CITY OF OPELIKA HISTORIC PRESERVATION COMMISSION

October 9, 2025

HISTORIC PRESERVATION COMMISSION MINUTES

Addition of sidewalk at side parking area

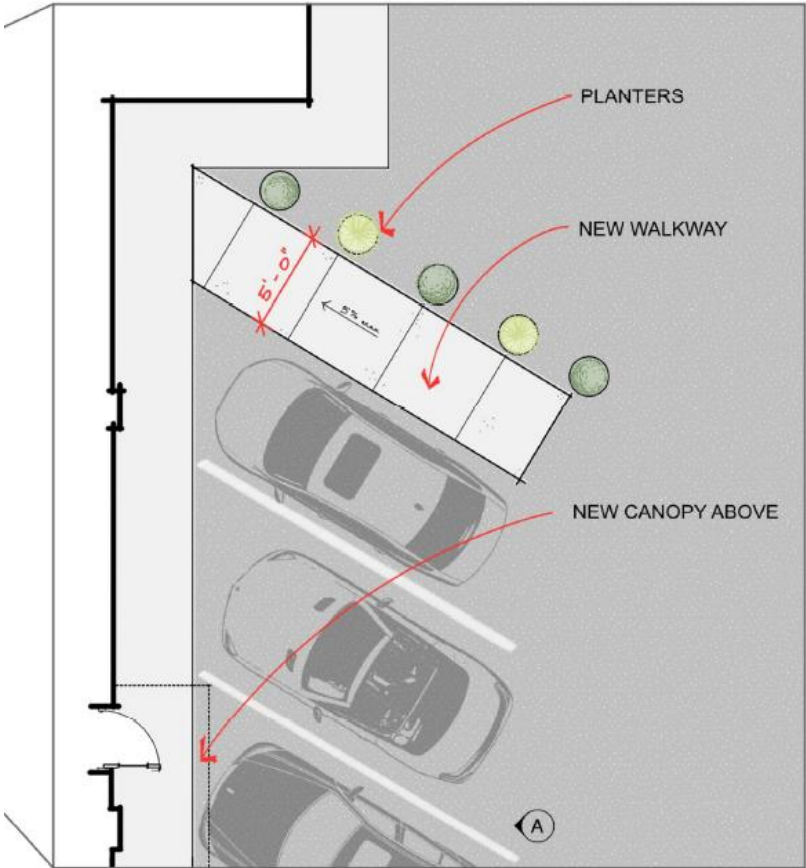
1. A new concrete walkway will be added to the northeast end of Stone Martin’s existing parking lot to enhance wayfinding and access to the new Design Center. The size and location are shown on the drawings.

WALKWAY MATERIAL TO BE CONCRETE
WITH TOOLED CONTROL JOINTS

1. Staff recommends approval of new concrete walkway at parking area on 1st Ave side for Design Center.
2. Staff recommends approval of revised painted signage matching the style, size, and color of the existing sign meeting sign regulations.

Change signage above right entrance

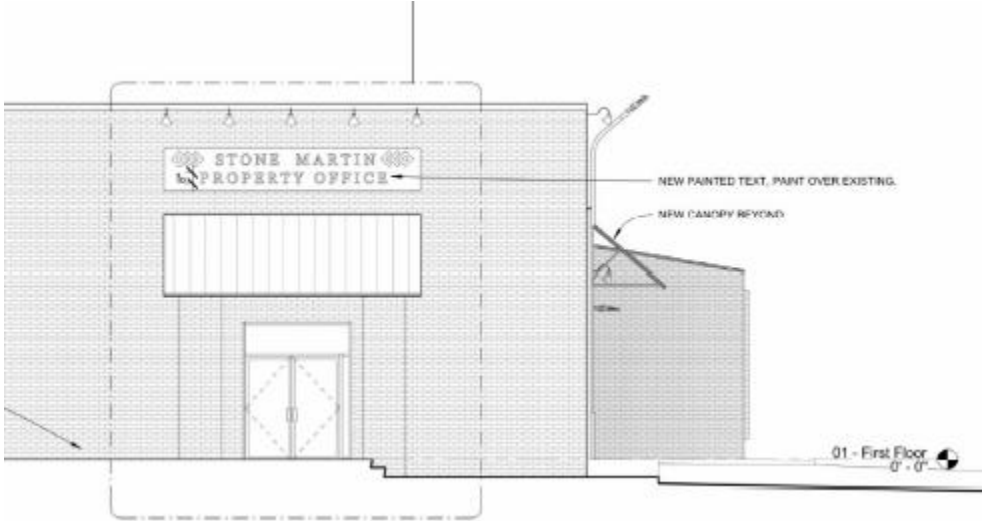
2. The existing sign facing N. 9th Street that reads “Stone Martin Commercial” will be altered to read “Stone Martin Property Office”. The style, size, and color of the lettering will not change.

New signage on N. 9th Street right entrance

Proposed changes to 1st Ave side

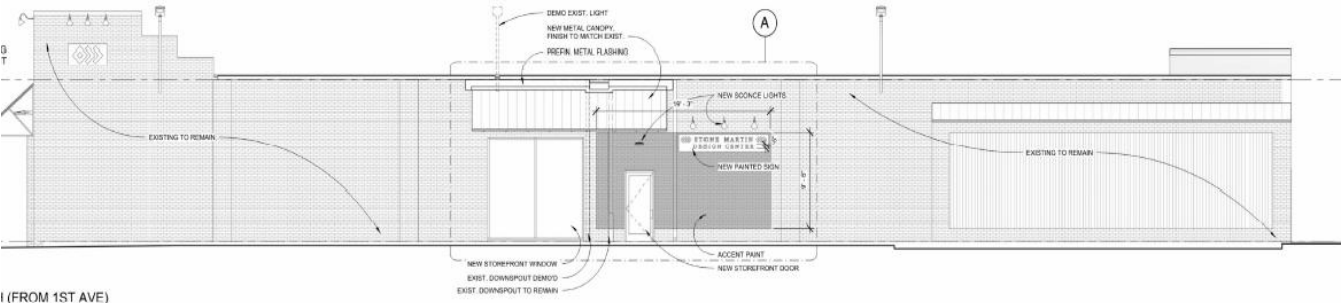
6. A 10’x10’ metal roll-up door will be replaced with a storefront window matching the finishes of the existing storefront doors.
7. A new sconce light will be added over the entrance to the Deign Center, and new sconces will be added to light the new Design Center sign.

(FROM 1ST AVE)
Facing 1st Avenue- Remove rollup door and install new storefront window and full glass door. Install metal awning, gooseneck lights, and painted signage.

Specs:

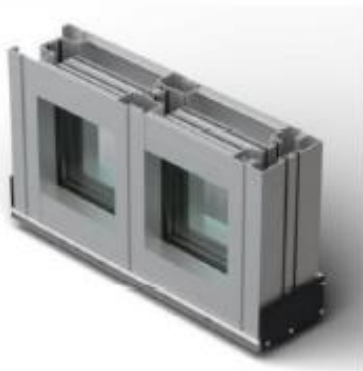
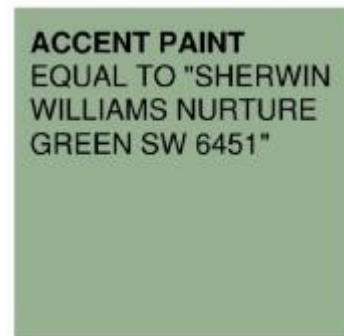
NEW DECORATIVE ENTRY SCONCE
EQUAL TO "THE ORIGINAL WAREHOUSE
GOOSENECK LIGHT - 24"

NEW SIGN LIGHTS TO MATCH CURRENT
MATCH EXISTING, EQUAL TO
"MILLENNIUM R-SERIES GOOSENECK
SCONCE"

STOREFRONT
EQUAL TO KAWNEER
451T, BLACK
ANNODIZED

ACCENT PAINT
EQUAL TO "SHERWIN
WILLIAMS NURTURE
GREEN SW 6451"

Landscape plan showing staggered double row of evergreens

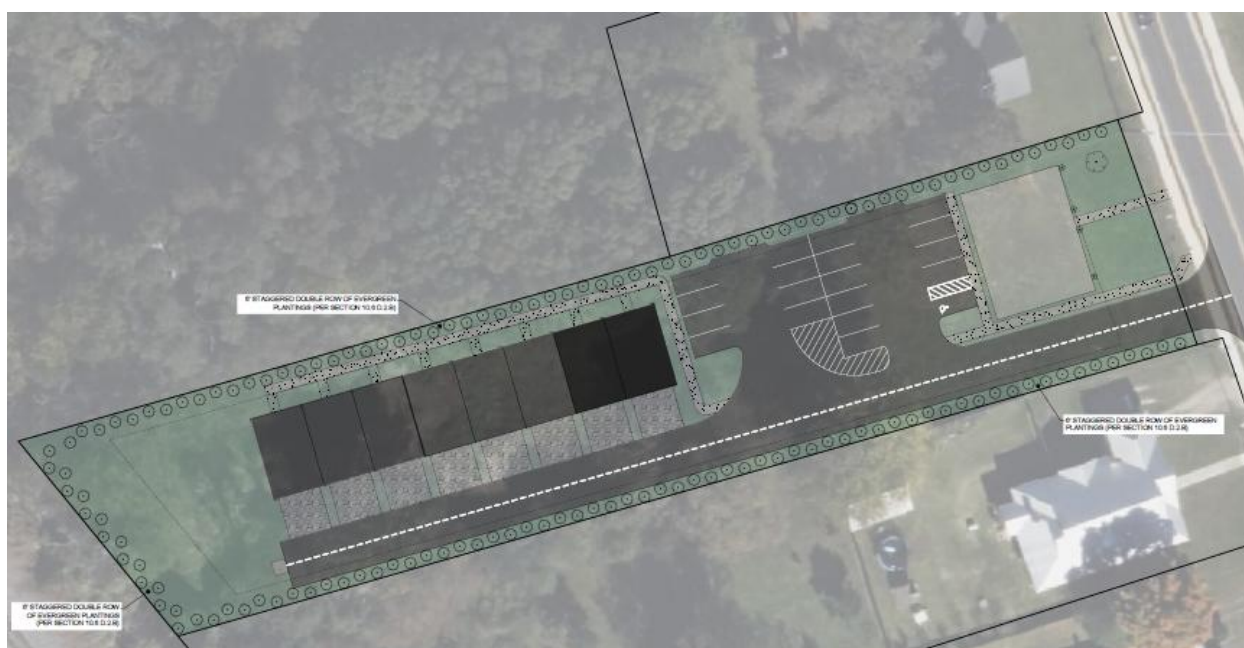
5. Staff recommends approval of new storefront windows facing S. 10th Street.
6. The applicant shall return with a landscape plan to block the view of rear parking.
